Technical Note in respect of highways and transport issues to support the response by Mountnessing Parish Council to the transport assessment included with the planning application submitted by Taylor Wimpey for a residential development

16th November 2025

Introduction

Figure 1 – dropped crossing serving 121a Roman Road

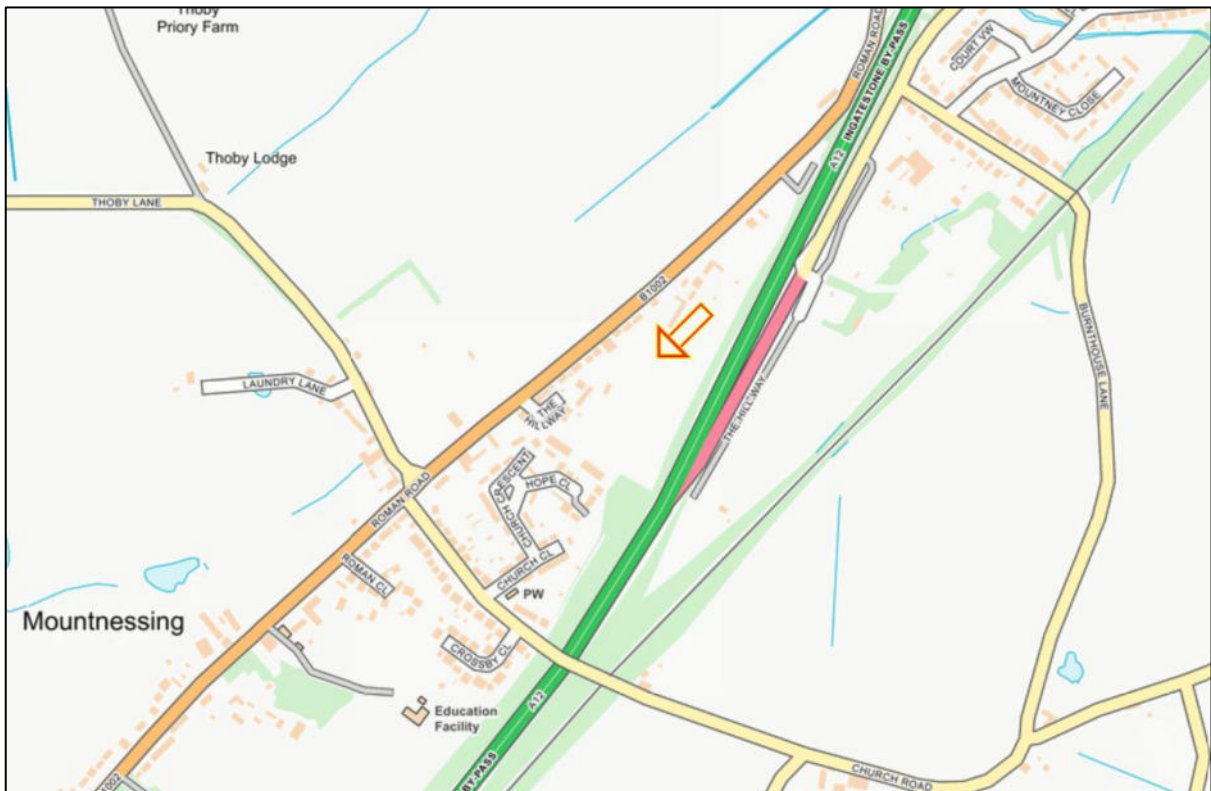
It is a relief to the owner that all the dropped kerb is not planned to be removed but it is difficult to see how vehicular access for 2 vehicles can be achieved for the property when only 3 metres of the current 6 metres dropped crossing is suggested to be retained. The developer has no right to do this without the property owners' permission, which should quite rightly anticipate the full 6 metres (i.e. the ability to park 2 cars on their frontage safely and conveniently, see **Figure 1** below).

Proposed Means of Access

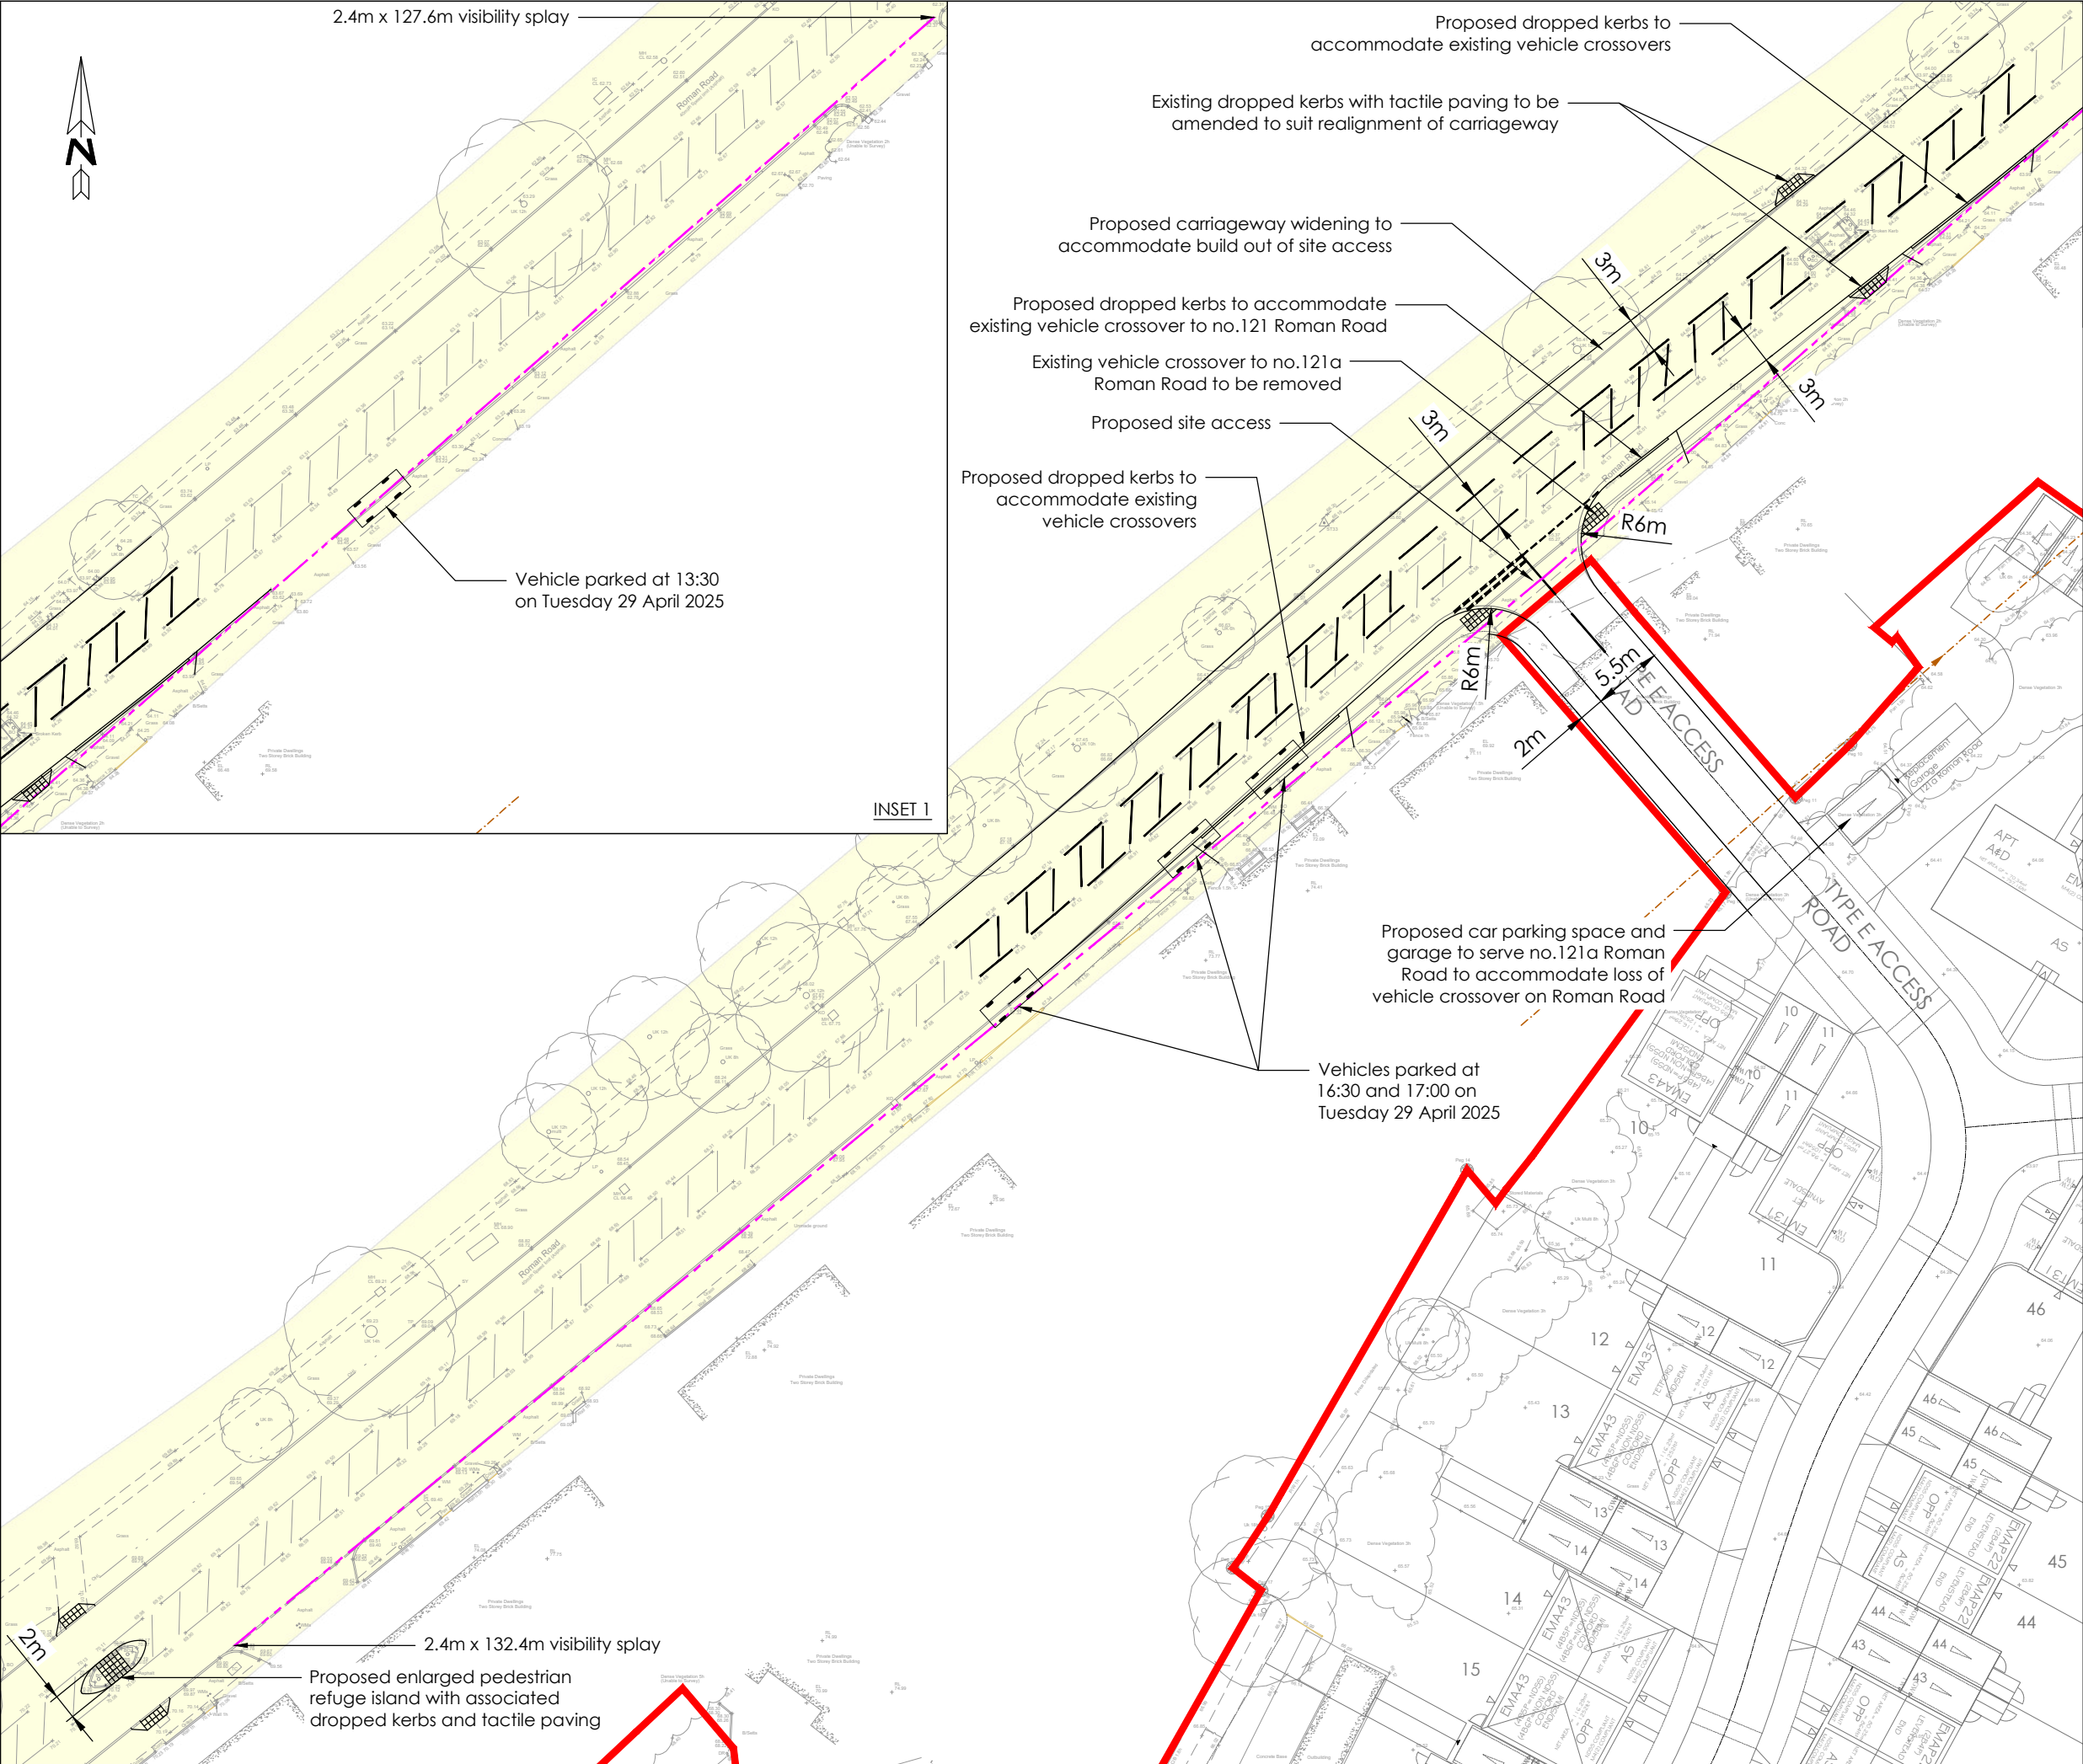
5.2 Proposed Access Arrangements – the means of access proposed is a Type E access road as per Essex County Council’s design guide, which is typically acceptable subject to suitable assessment of the junction visibility splays for the prevailing traffic conditions, swept path analysis of anticipated refuse vehicles expected to circulate the site layout considering possible parked vehicles on the proposed parking layout. A Type E road is usually anticipated to be a shared surface, low-speed, home zone-style street with no traditional kerbs and a single, level surface for vehicles and pedestrians but the report does not mention whether this is the case for this site.

The means of access drawing (see **Appendix A**) includes a note referring to the removal of the dropped kerb access to 121a Roman Road and replacement by the provision of a garage and a parking space in front of it, to the rear of 121a Roman Road. This proposal had not been discussed with the owner of 121a Roman Road prior to the application submission and would remove the legal right of vehicular access to a private property from the public highway and cannot take place without the permission of the legal property owner. Since HTP were commissioned to advise on the proposals a letter has been received from Taylor Wimpey London by the owner/relative of 121A Roman Road, as follows:

Furthermore, with reference to Essex County Highways pre-application advice, *"It is clear that the access is constrained by other dwellings alongside. It is very important that accesses to those dwellings are shown in any formally submitted drawings. In particular, it must be shown that the neighbouring access does not encroach into the site access bellmouth."* Bearing this in mind the developer would need to obtain the permission of the owner of 121a Roman Road to reduce the length of the dropped kerb and/or avoid encroaching on the bellmouth/ radii of the new access junction.

Regarding the originally proposed garage as a replacement to the rear of 121a Roman Road (for the loss of frontage car parking) on the application drawings it appears to be around 3 metres in width whereas Essex County Council guidance would expect a minimum of 3.3m to allow the driver of car parked in it to conveniently open their car door. In fact, the report refers to garages being proposed on the development site with a minimum of 3.4m internal width. Had the owner of 121a Roman Road been consulted about the possible replacement of their frontage vehicular parking by a garage and car space to the rear of their property they should have been advised to consider whether they would wish to have to walk the length of their rear garden to reach them, traverse a section of open land where the line of a shared sewer runs behind the properties and also be content with the personal and vehicular security issues arising from this arrangement.

5.3 Stage 1 Road Safety Audit – the Road Safety Audit and subsequent Designers Response are satisfactory. However, should the means of access/junction design be amended to take into account a retained/altered dropped kerb for 121a Roman Road close to or impinging on the bellmouth this aspect would need to be considered for the safety implications for both vehicles and pedestrians.

- 6) Should the amendment to the application plan showing the means of access/junction to the development site reduce the dropped kerb to less than the existing length without the owner of 121a Roman Road being consulted and agreeing to this, it would be illegal and the developer does not have the power to do this. The means of access drawing should be amended to remove the proposed garage and access to the rear of 121a Roman Road.
